Access Compliance Report

Public Rights-of-Way

(Pedestrian Signals)

Intersection ID: N/A	Main Street:	Cross Street: N/A	Location: N/A
ADA ID: 6EC7A1E70BB8	Signal Type: One Push Button-Non APS	Overall Compliance: No	Severity Score: BTN 1: N/A BTN 2: N/A No BTN: N/A
Codes/Mitigation Info/Possible Solution		Field Measurements/Component Compliance

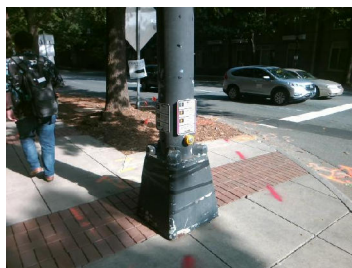
Surveyor Notes: TEXT HT 1/4

PROW/ADA: R410.6, R404.2, R406.2

Possible Solutions: Remove & Replace Sign. Provide Push Button Extension. Remove and Replace Clear Space.
